Sunset Garden Senior Living Apartments

SITE PLAN 236 UNITS

Site Plan
Building F
PRMU20240281

Bradley Heights Apartments
Puyallup, Wa

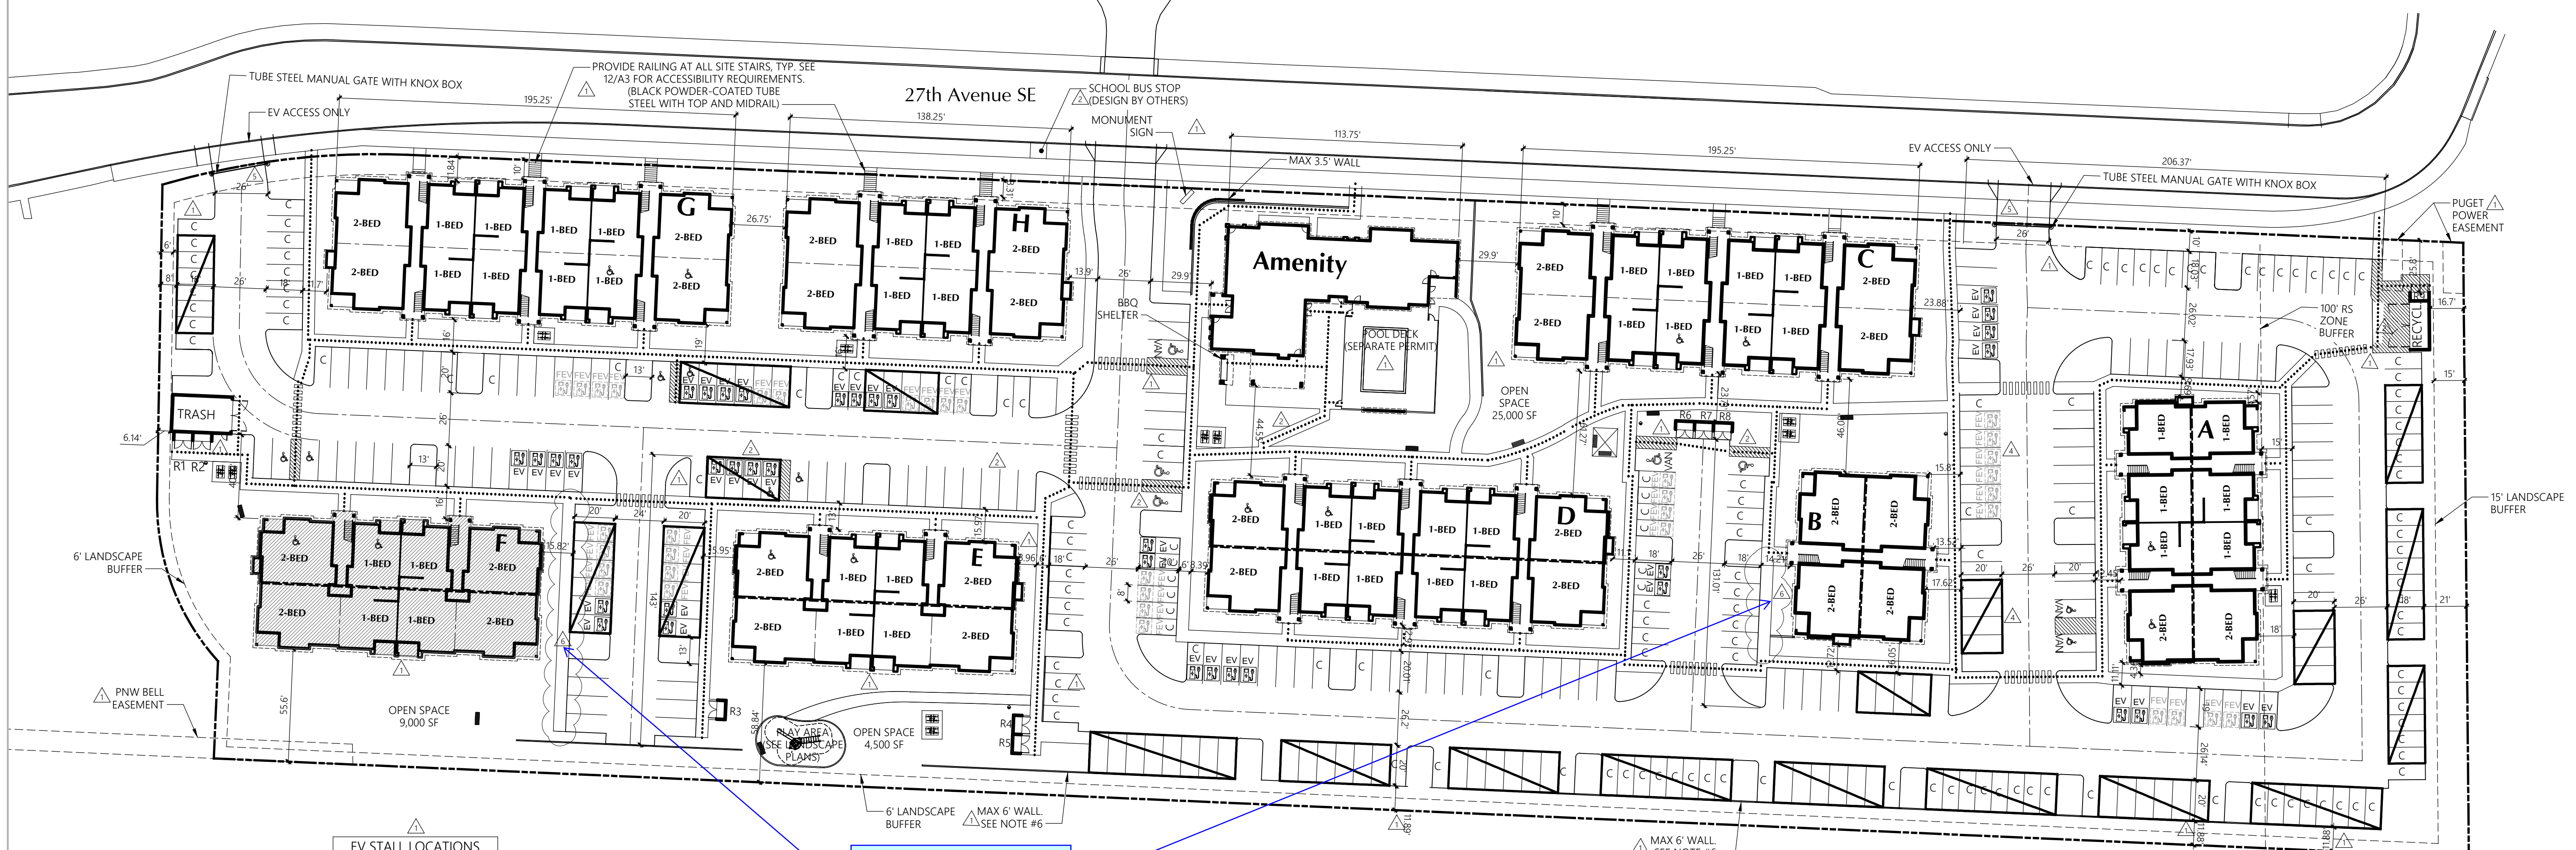
EV STALL LOCATIONS ADDED TO SITE PLAN

EV STALL LOCATIONS UPDATED

Revision note #6 is to remove sidewalks that are unable to meet the maximum slope required for the Accessible Route of Travel (ART), per architect.

PARKING COUNTS CORRECTED
